Anker Innovations Limited

Declaration of Product Modifications

This is to request a Class II permissive change for FCC ID: 2AOKB-T8171,
originally granted on 11/21/2025

Difference	Original	New
For USB board

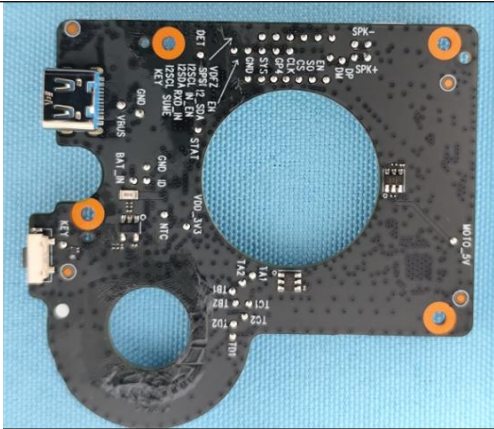
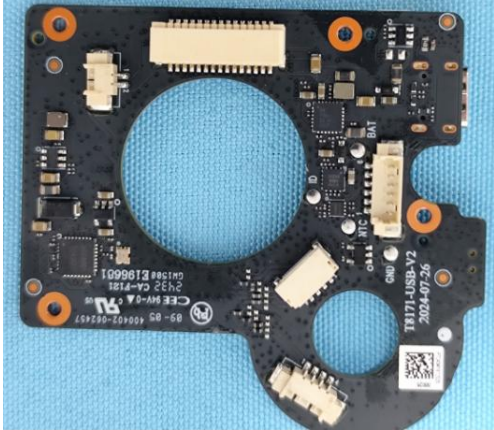
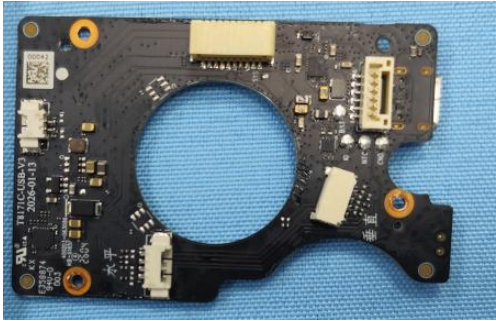
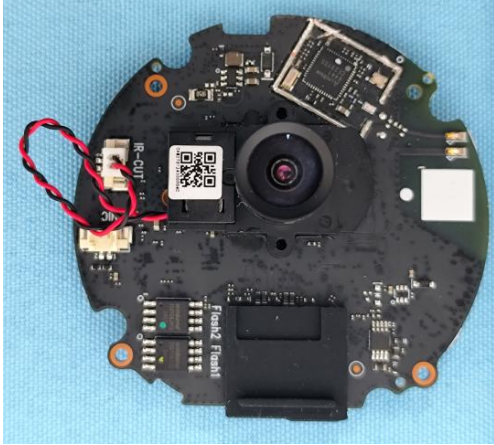
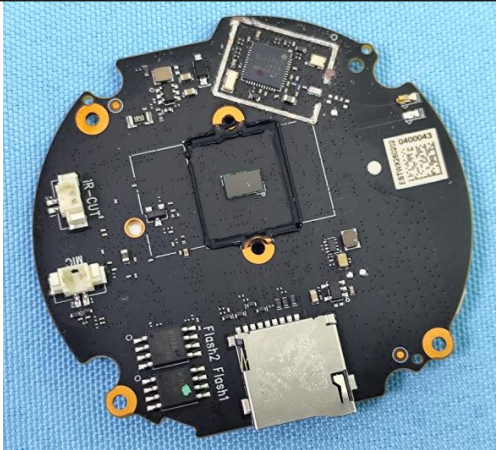
Difference		Original	New
For USB board	1. Change Motherboard and USB connector	30-pin dual-row connector with 1.0mm pitch	20-pin 1.0 dual-row 1.0 pitch connector
	2. Change Motherboard and USB cable	30-pin double-row electronic cable with 1.0mm pitch	20-pin 1.0 dual-row 1.0 pitch electronic wire
	3. Delete Linear charging chip	SGM4056-6.8YTDB8G/TR	NA
	4. Delete Solar charging current detection chip	INA180B4IDBVR	NA
	5. Delete Solar power connected to a pull-up power supply.	LPW5202FDB5F21	NA
	6. Delete Magnetic angle encoder	TMAG5273A1QDBVR*3	NA
	7. Update motor driver chip	HTD9901QNP	HTD9900IONJ
	8. Update charging management chip	BQ25611	SGM41551
For Main board	1. Update motherboard and USB connectors	30-pin dual-row connector with 1.0mm pitch	20-pin 1.0 dual-row 1.0 pitch connector
	2. Remove audio amplifier power supply	TLV61070ADBVR	NA
